## NUCLEAR REGULATORY COMMISSION

Title: Advisory Committee on Reactor Safeguards  
Power Upgrades Subcommittee:  
OPEN SESSION

Date: Friday, March 21, 2008

SUBCOMMITTEE ON POWER UPRATES

# Hope Creek Steam Dryer Design

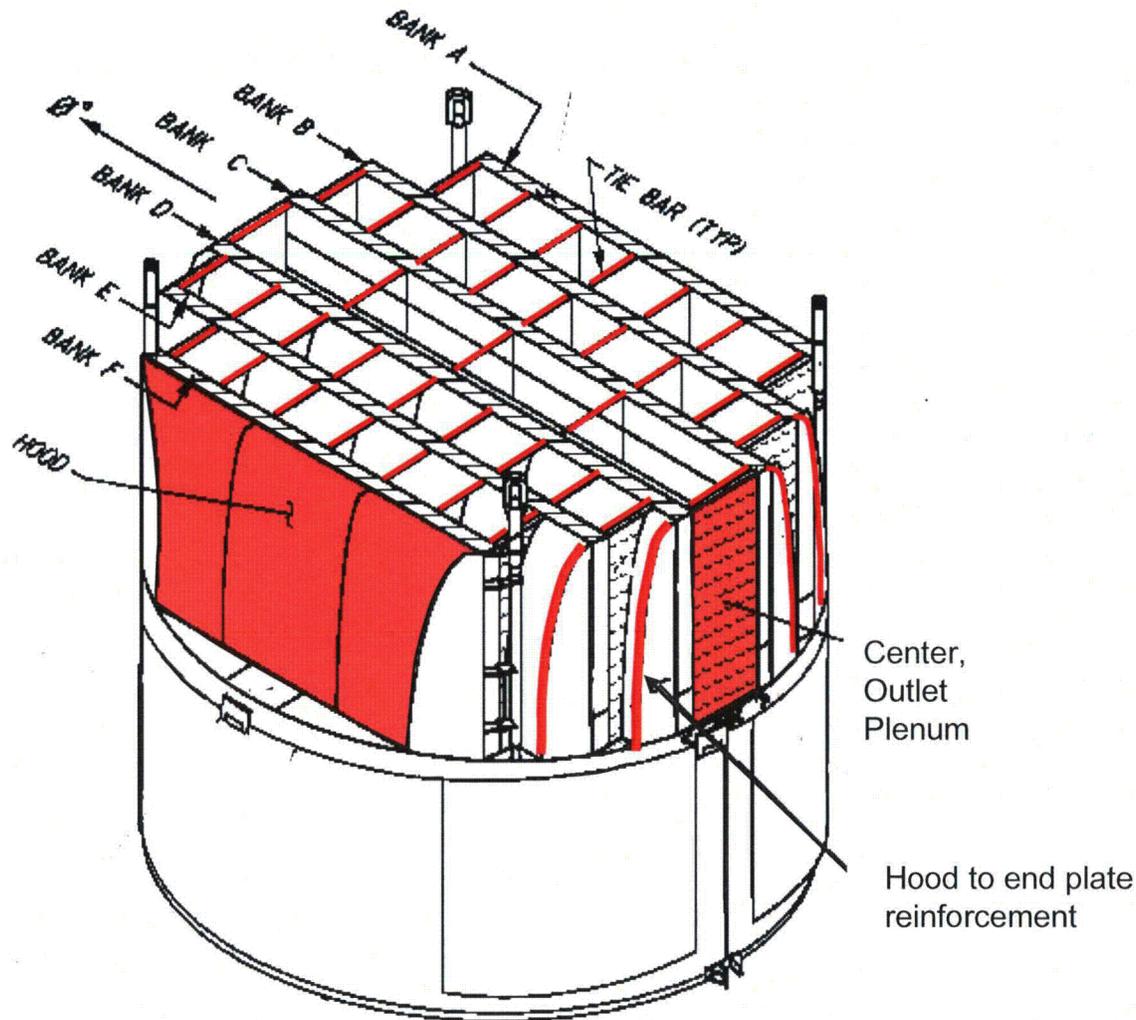
5 Hope Creek's curved hood dryer is the  
6 third generation of steam dryers designed by General  
7 Electric. It's an improvement over the square hood  
8 design that failed Quad Cities. The curved hood  
9 design creates less turbulent steam flow through the  
10 dryer and into the main steamlines, which reduces  
11 dryer operating stresses. That will be in detail in  
12 the closed session.

15 CHAIR ABDEL-KHALIK: What was the  
16 modification for that modification at the time?

17 MR. DAVISON: At the time, and actually  
18 cover that on the next slide, but it was driven by  
19 industry operating experience. And I'll go actually  
20 through every modification that we did on the next  
21 slide.

**Reinforced middle and  
inner hood to end plate  
joint**

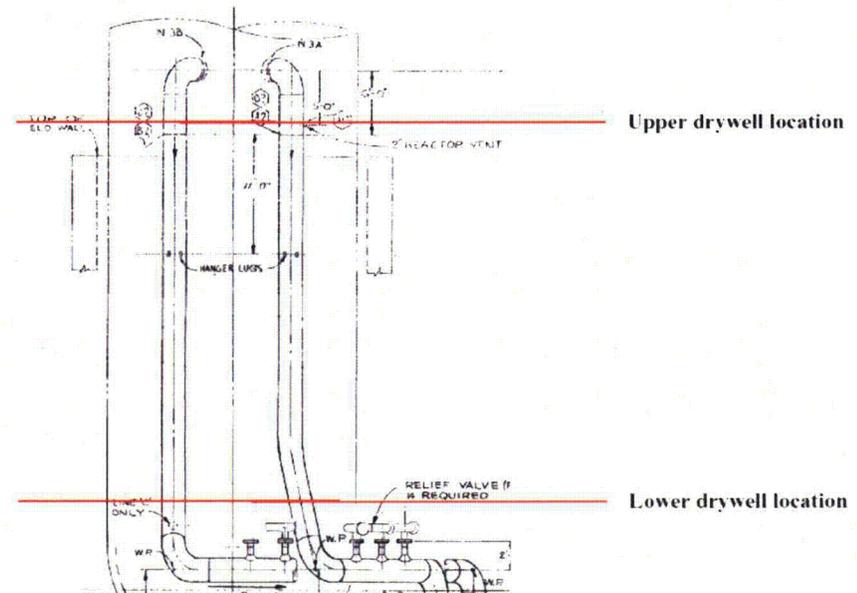
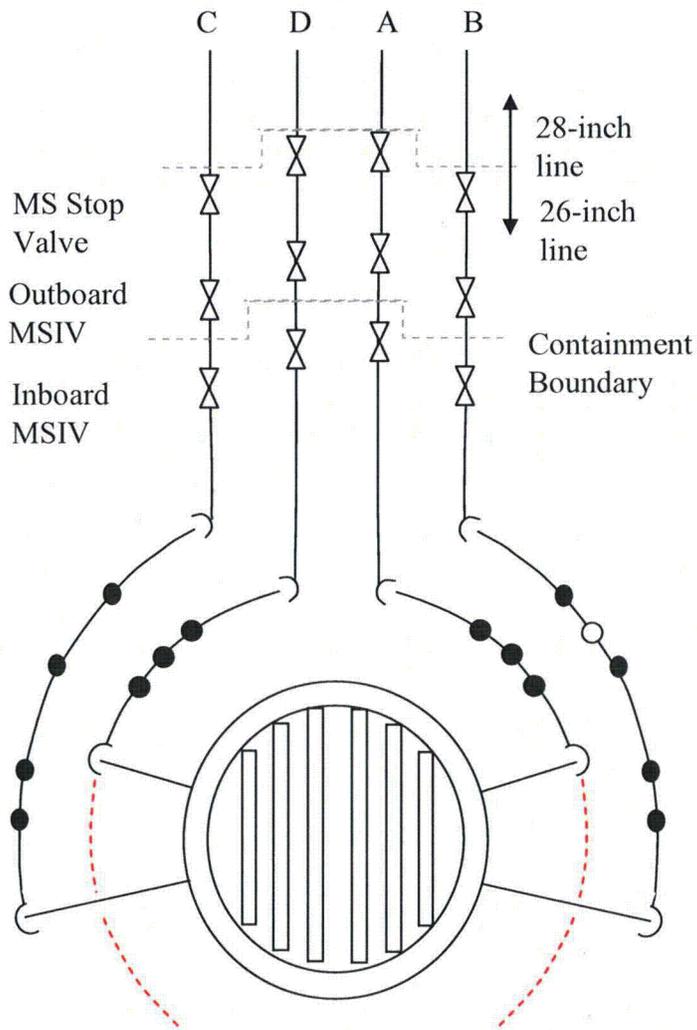
15                   This is a picture of the steam dryer with  
16 pre-operational enhancements that I talked about mods  
17 shown in the red colors.   The General Electric approved  
18 modifications were installed to address operating  
19 experience specifically from Toaki and, actually,  
20 Susquehanna.

4 The inner and middle hood to end plant  
5 joints were reenforced with external strips and  
6 internal backing welds. The strips are 3/16th by 2  
7 inch wide stainless steel that were welded to the end  
8 of the hood but overlapping the joint to the end  
9 plate. The back weld was performed on the inside of  
10 the hood for additional strength. Obviously, we could  
11 do this because it was not irradiated. It was before  
12 we did initial operations.

7 DR. WALLIS: -- was that the same as this?  
8 Did it have the same modifications or what was it  
9 like?

10 MR. DAVISON: The steam dryer that was  
11 essentially abandoned, but we still had it, did not  
12 have all these modifications put into it since it was  
13 never --
